Environmental Re-evaluation

ENVIRONMENTAL
IMPACT STATEMENT

Subject: Mountain View Corridor, Salt Lake County and Utah County Final Environmental Impact Statement and Final Section 4(f) Evaluation dated September 2008; Record of Decision dated November 17, 2008

Re: Mountain View Corridor Environmental Re-evaluation #2
UDOT Project Number *SP-0067(3)0

Figure A-06

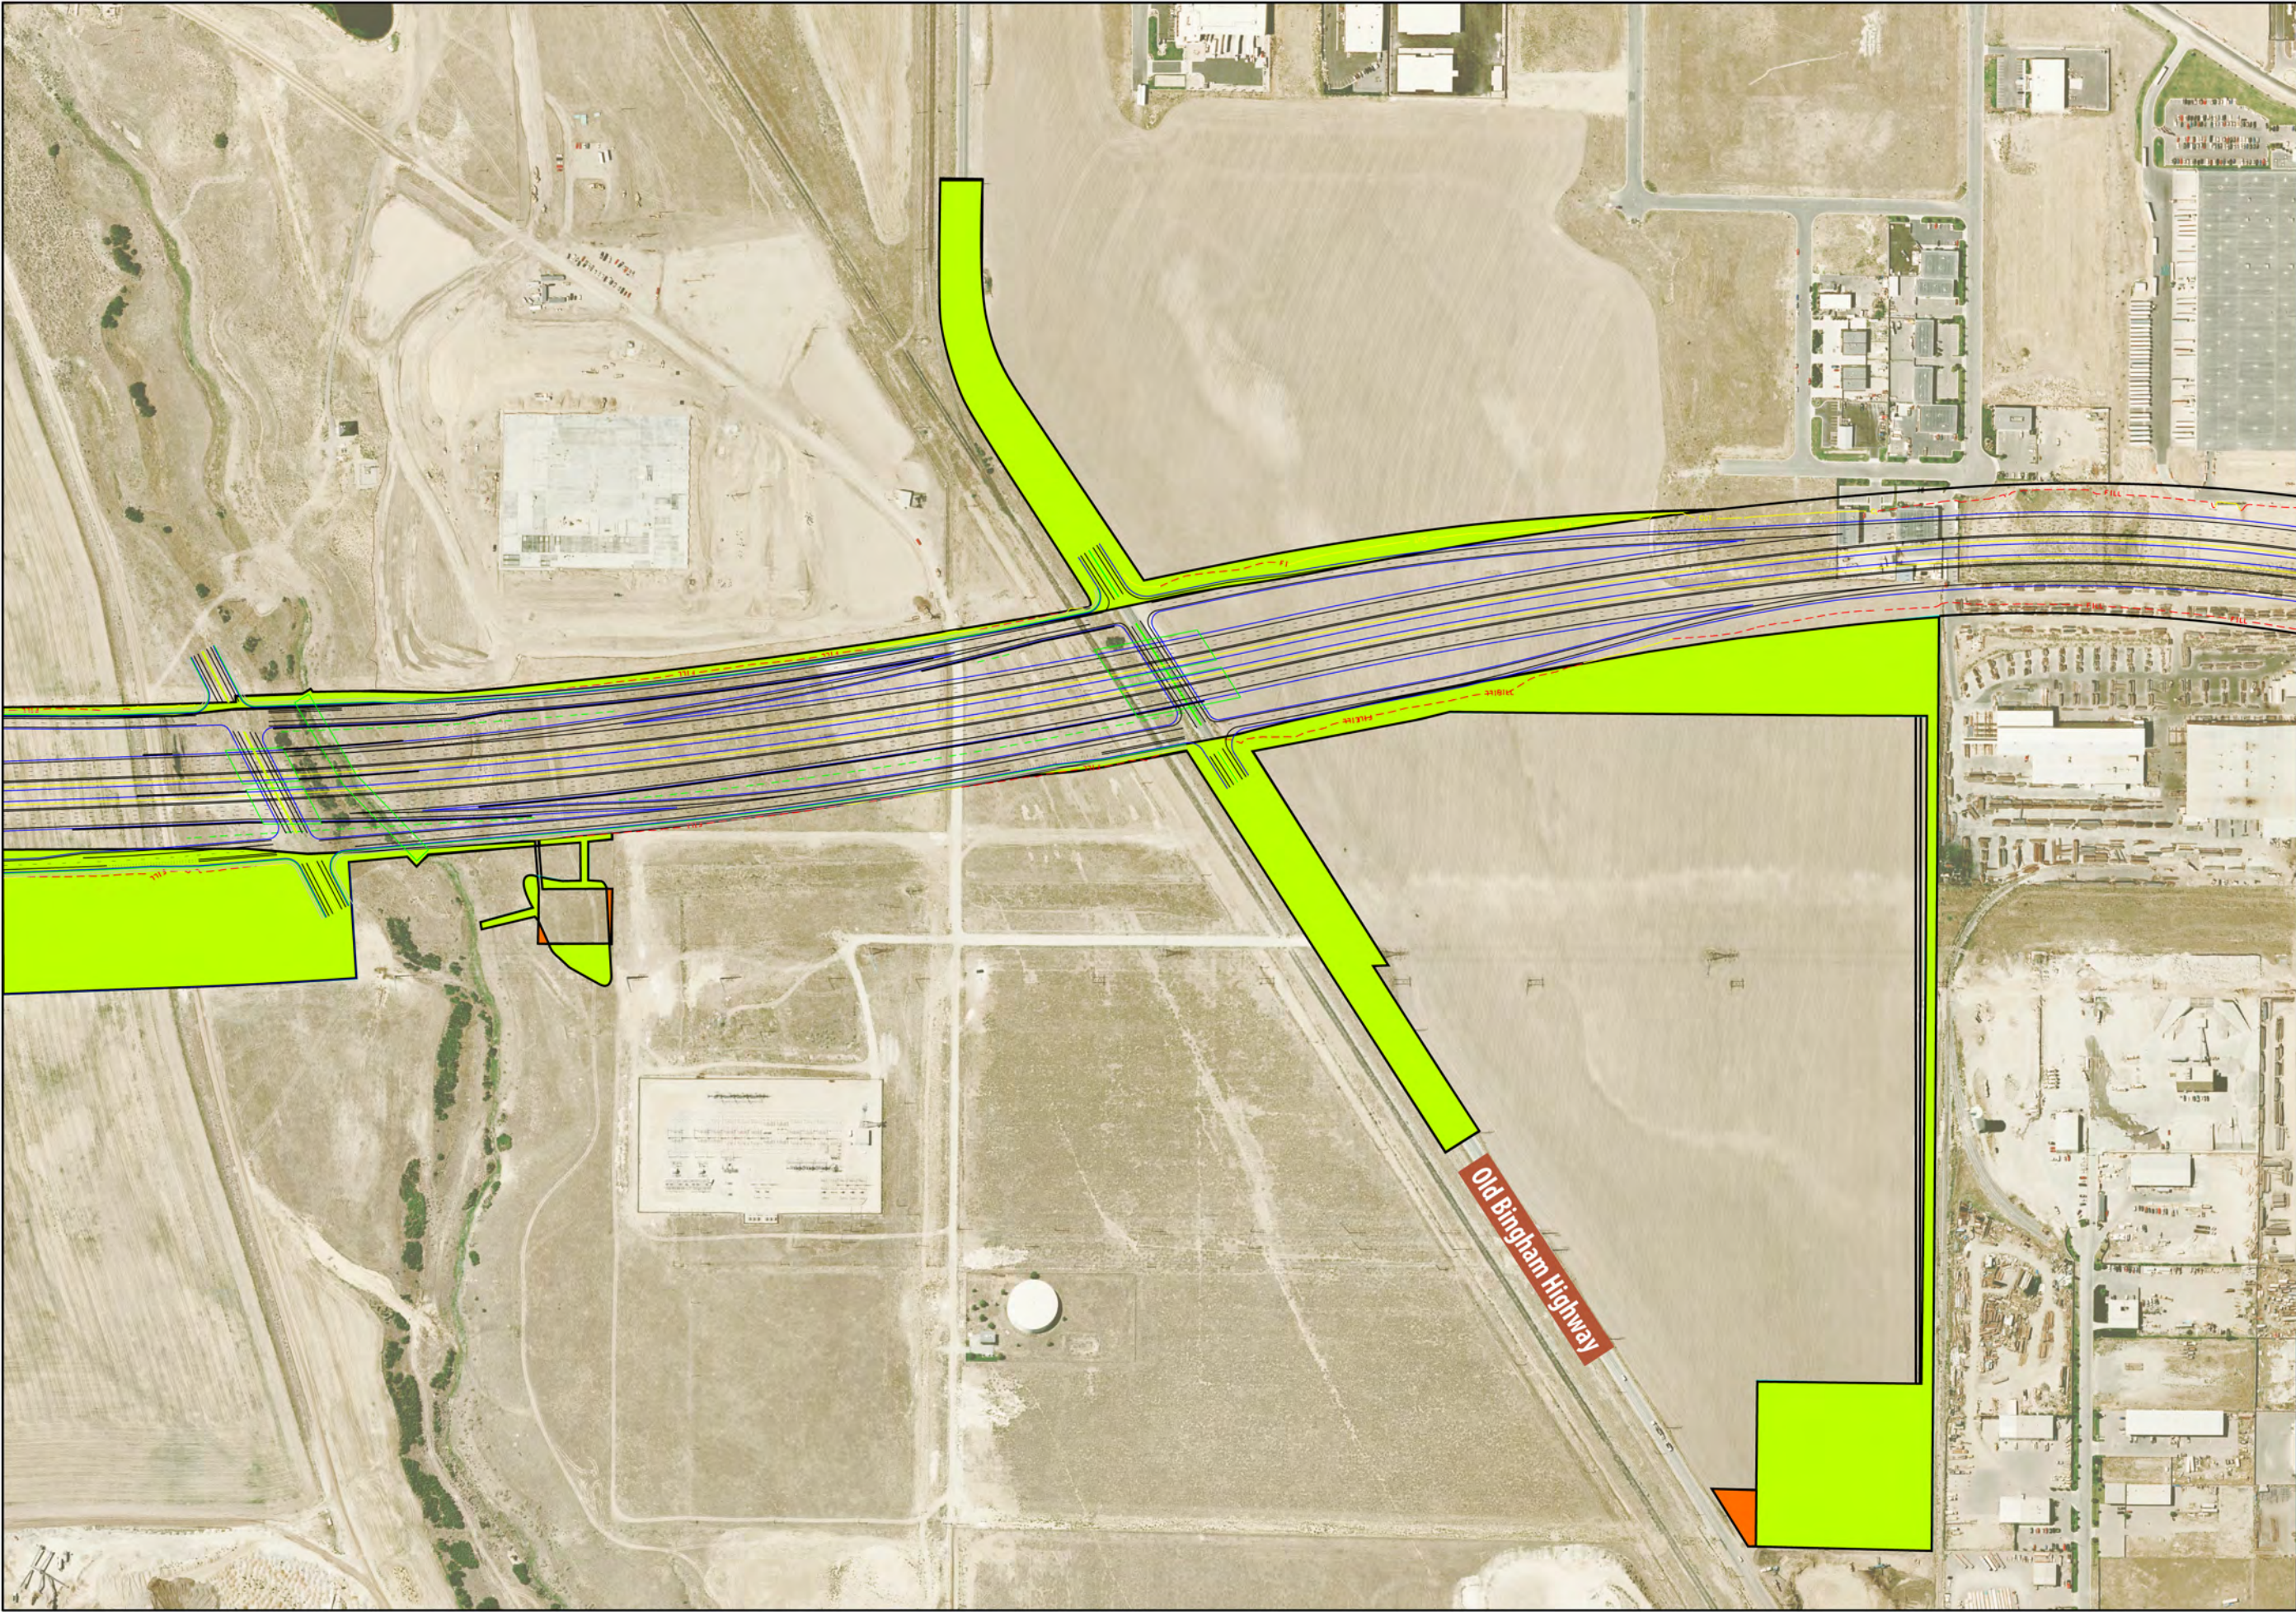
- South Jordan Parkway
 - In order to match the most recent street plan of the City of South Jordan, the orientation of South Jordan Parkway would need to be adjusted to connect to the MVC interchange (see Appendix A, Figure A-06).

Figure A-07

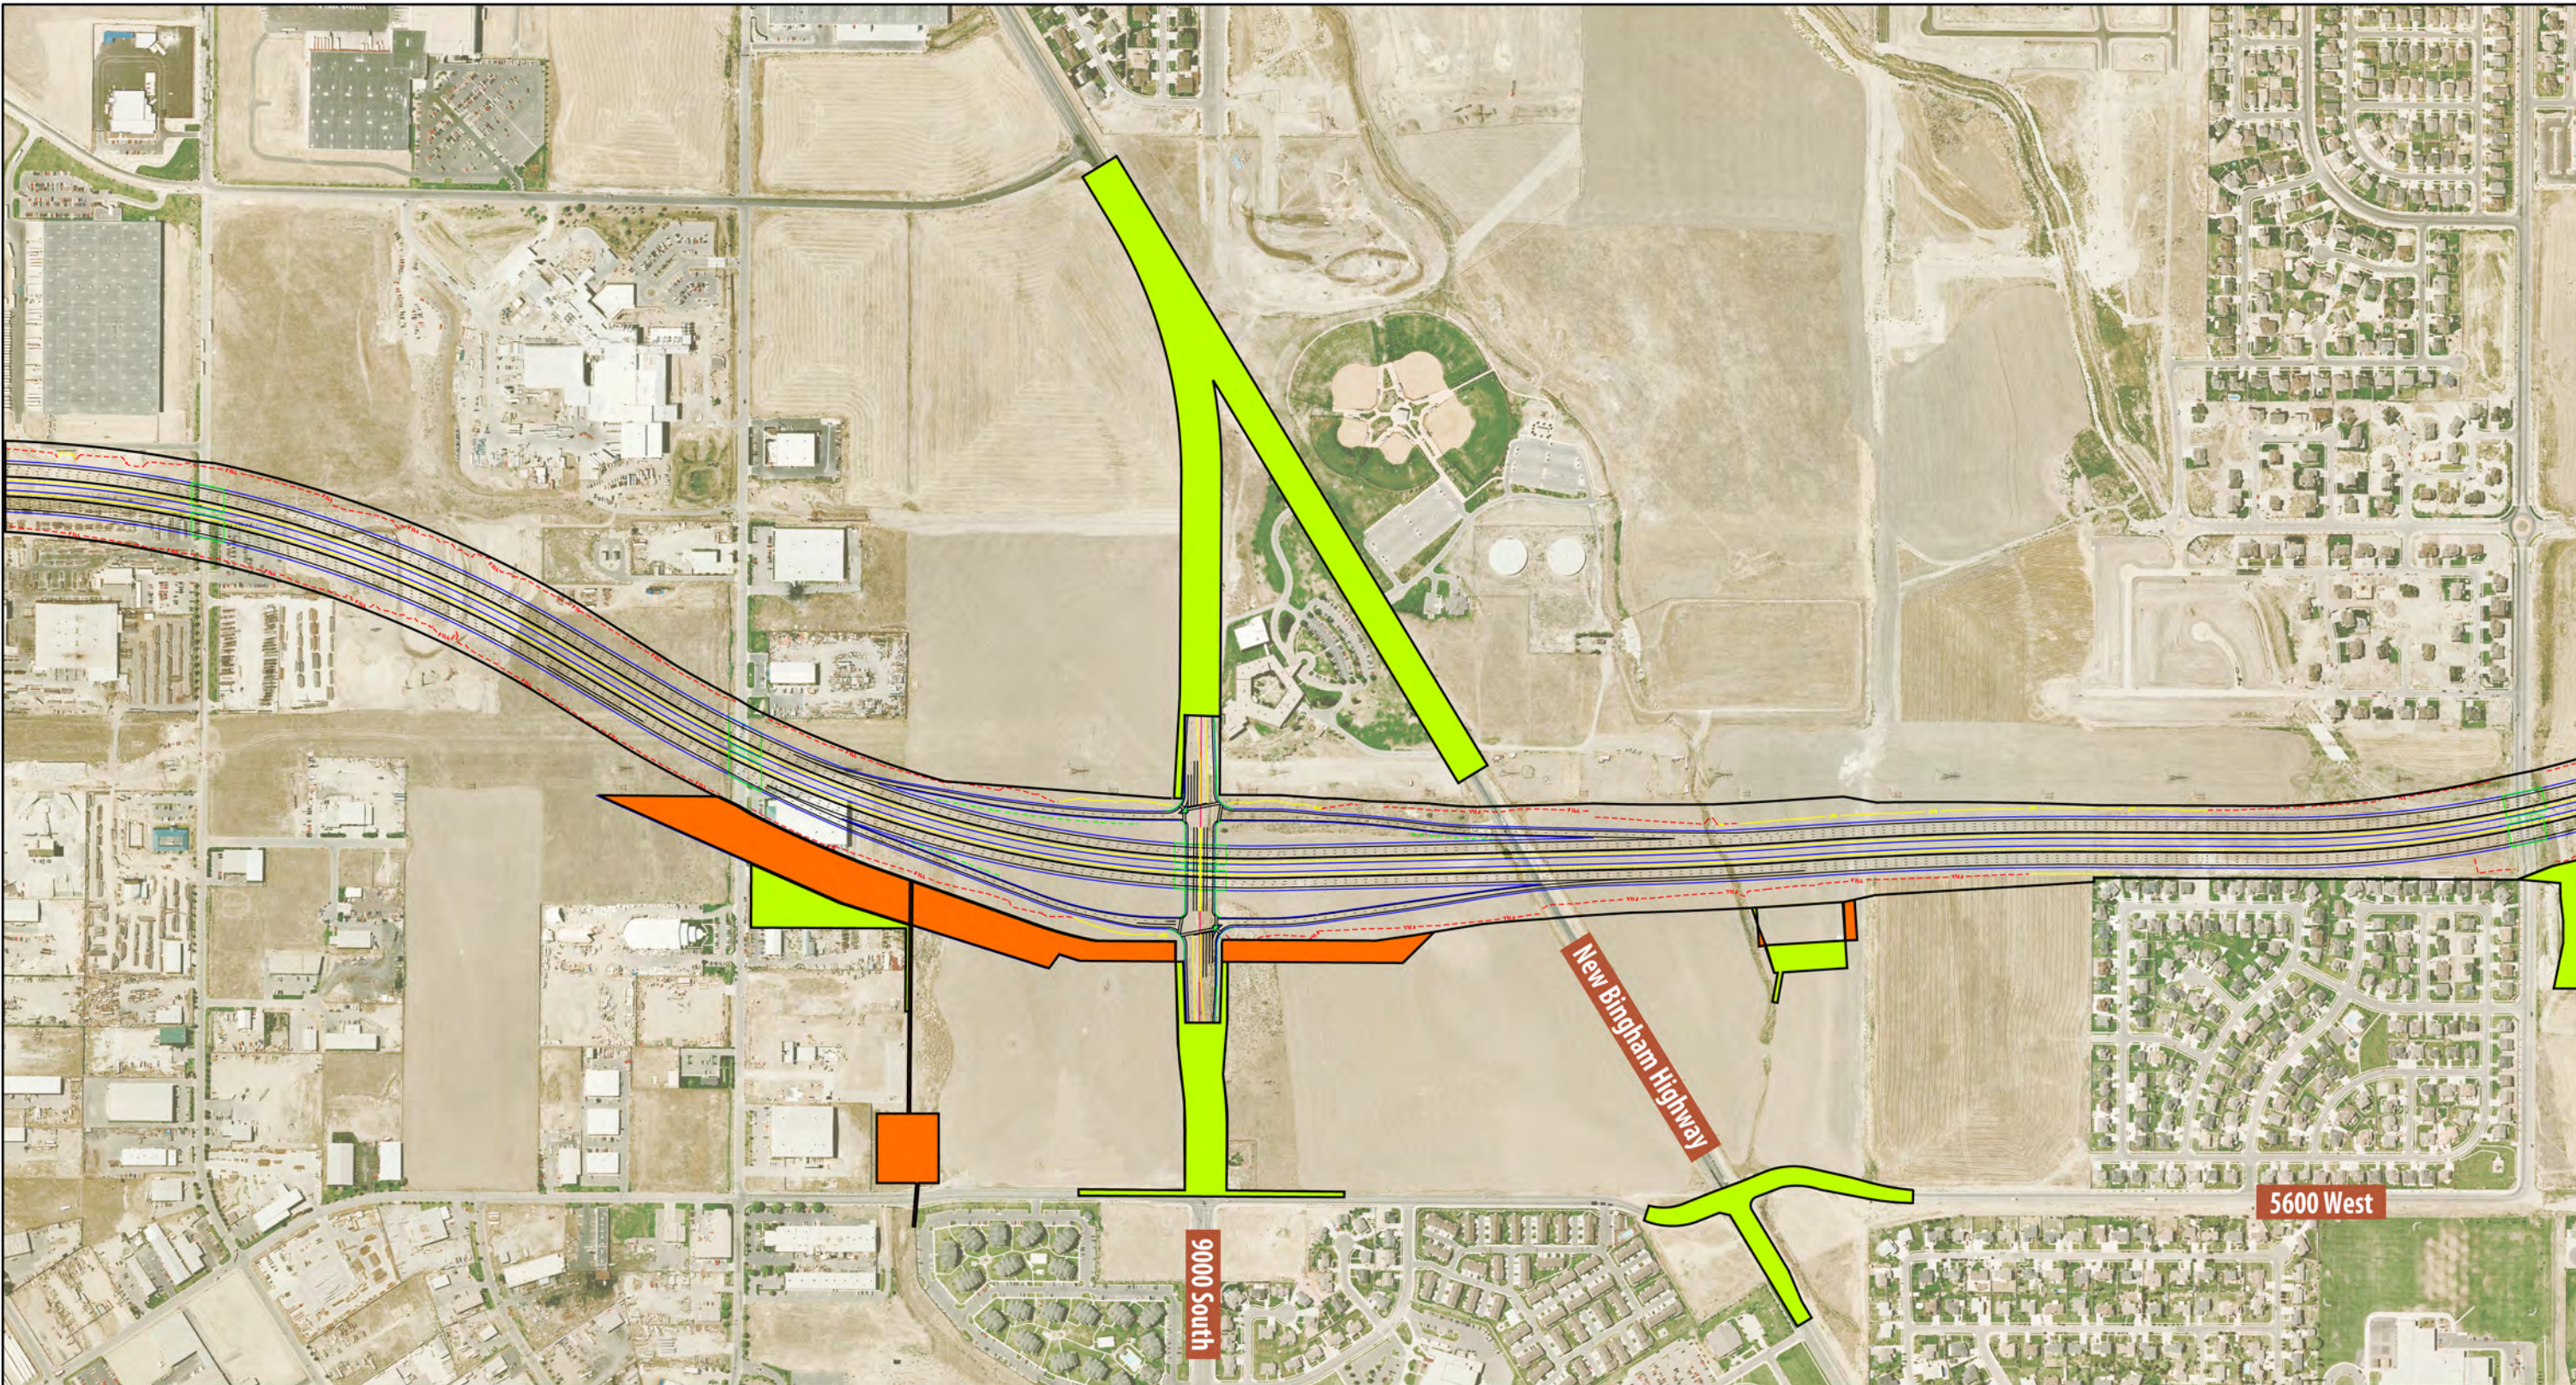
- Old Bingham Highway
 - The Final EIS did not evaluate a connection of the MVC to Old Bingham Highway. To provide access, the EIS footprint would need to be widened to accommodate turn lanes from the frontage roads (see Appendix A, Figure A-07).

Figure A-08

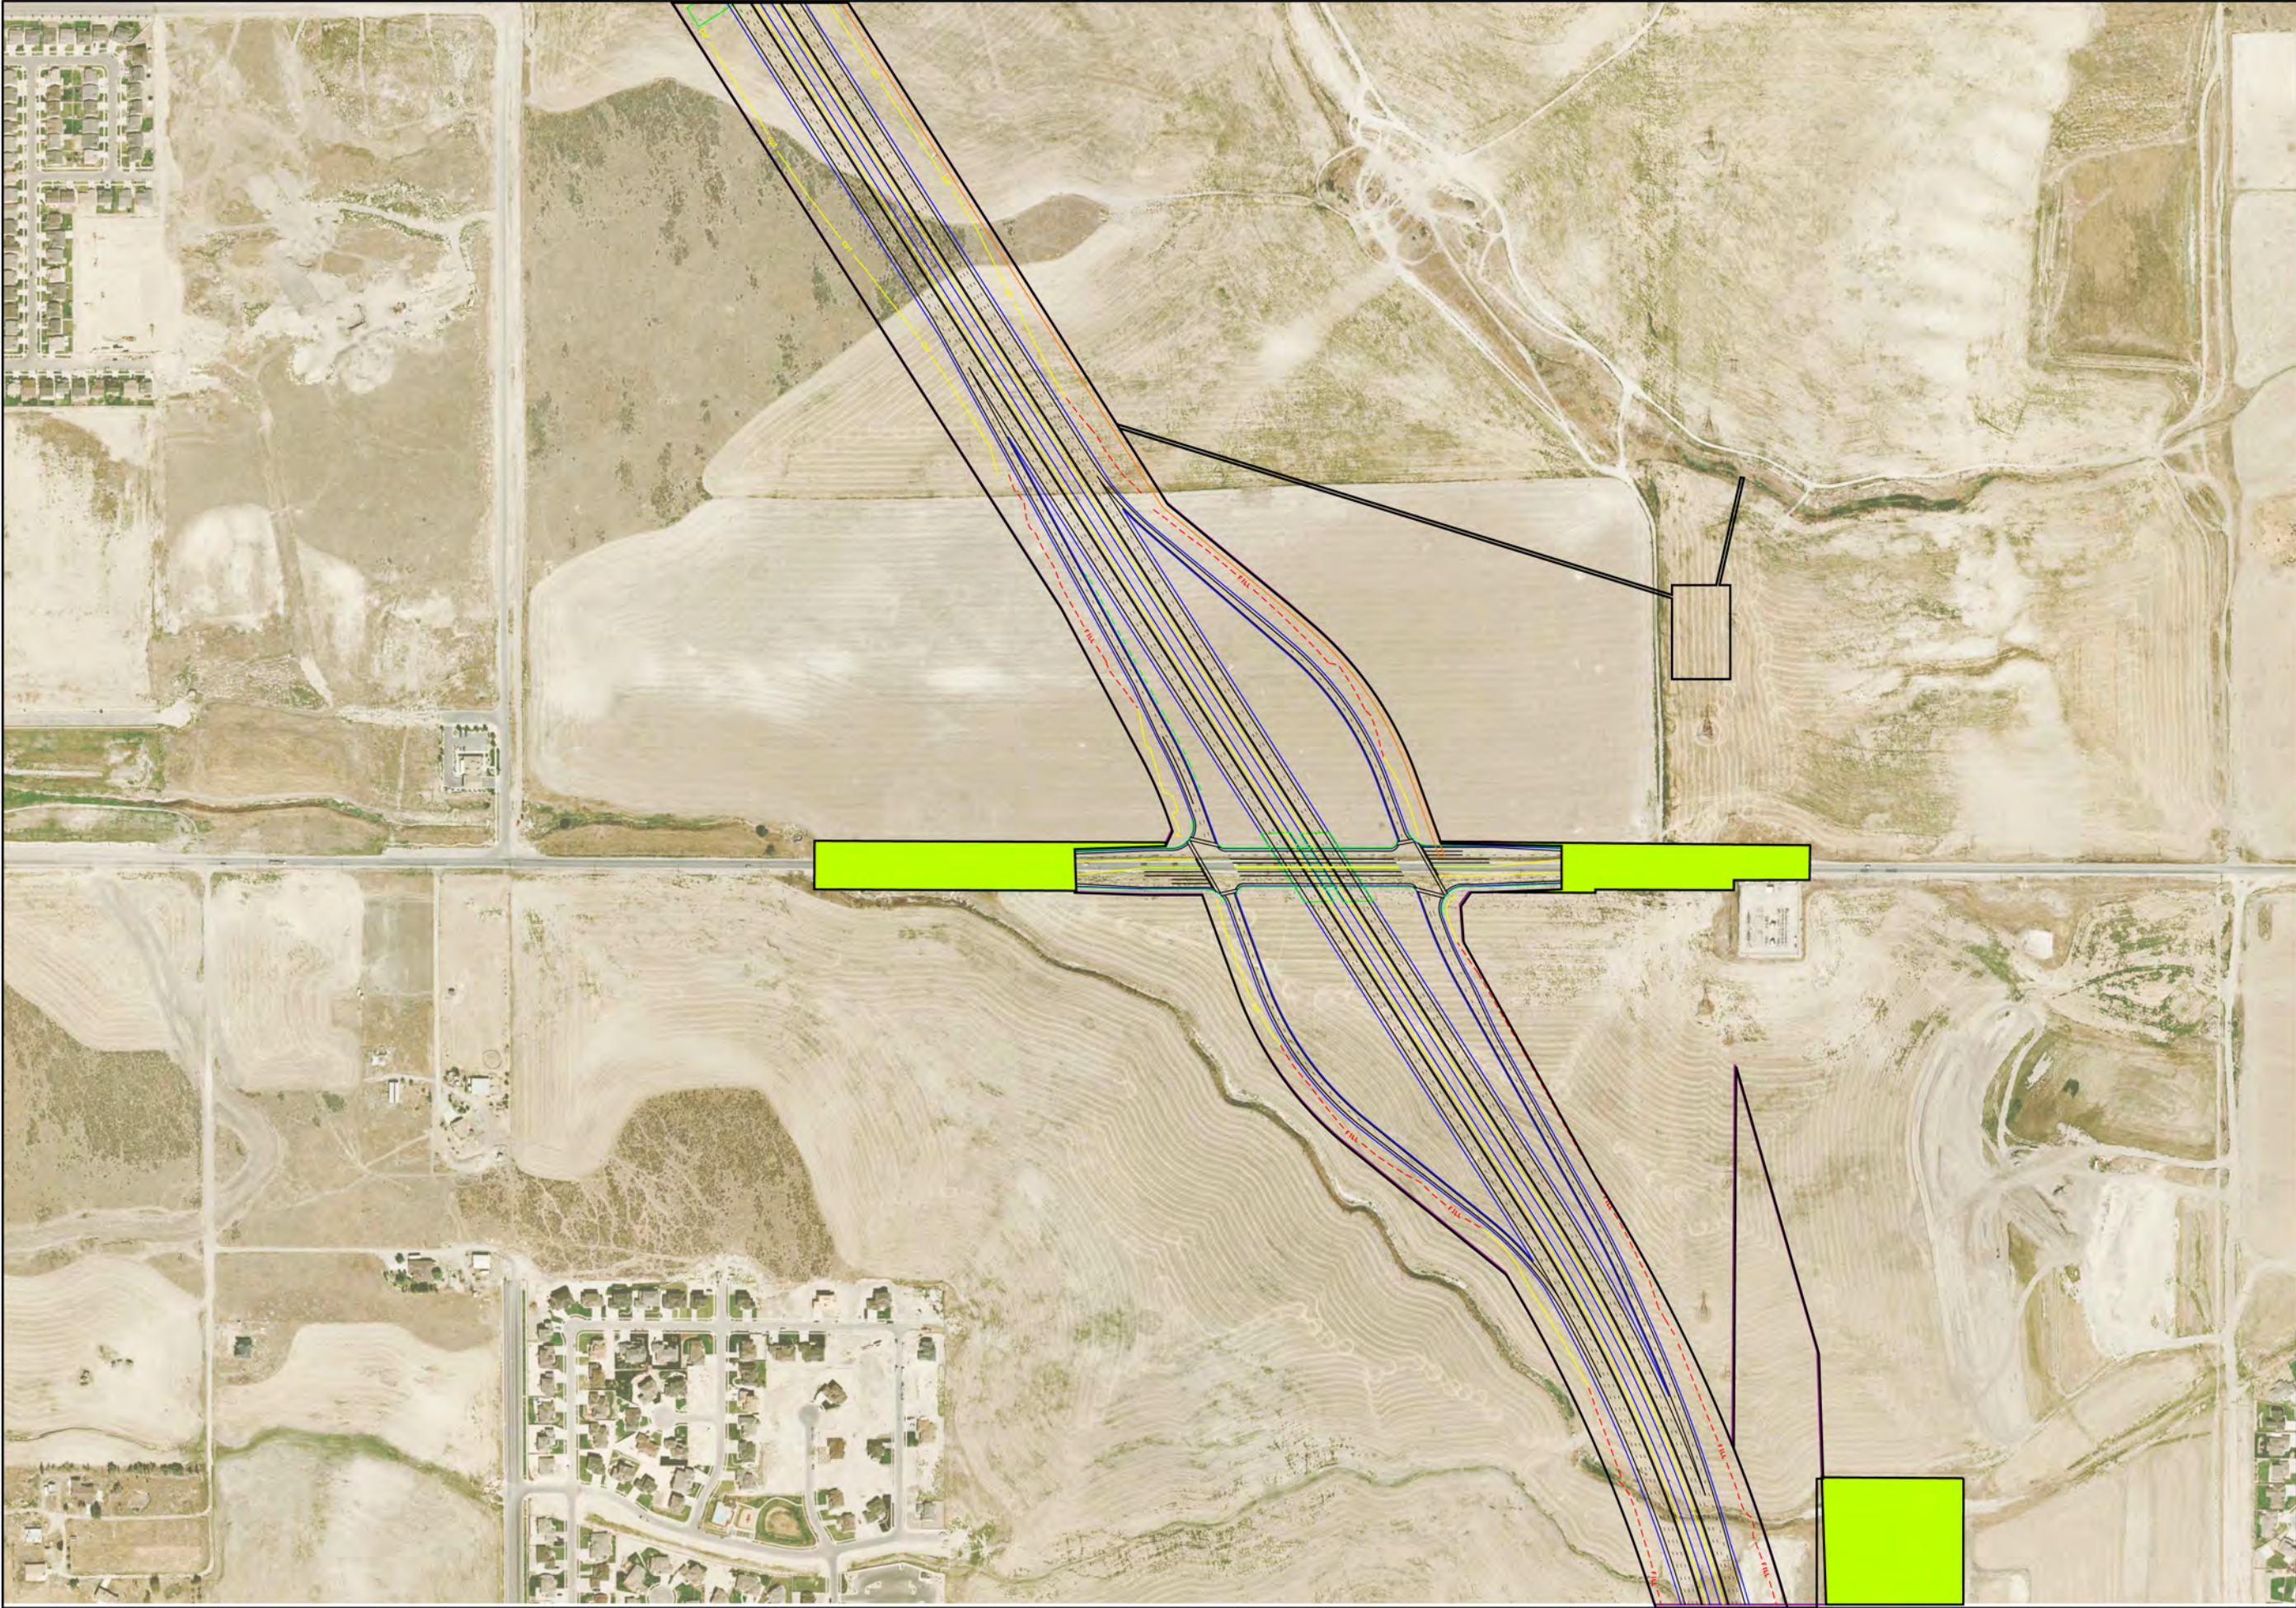
- 9000 South
 - At 9000 South, the footprint analyzed in the Final EIS would need to be extended to allow the connection of 9000 South from 5600 West to New Bingham Highway (see Appendix A, Figure A-08).

- New Bingham Highway
 - Improvements at the intersection of 5600 West and New Bingham Highway would be required to facilitate traffic movements east to west along New Bingham Highway. New Bingham Highway would be closed at the MVC and traffic diverted to 9000 South or 5600 West (see Appendix A, Figure A-08) including any trail accommodations.
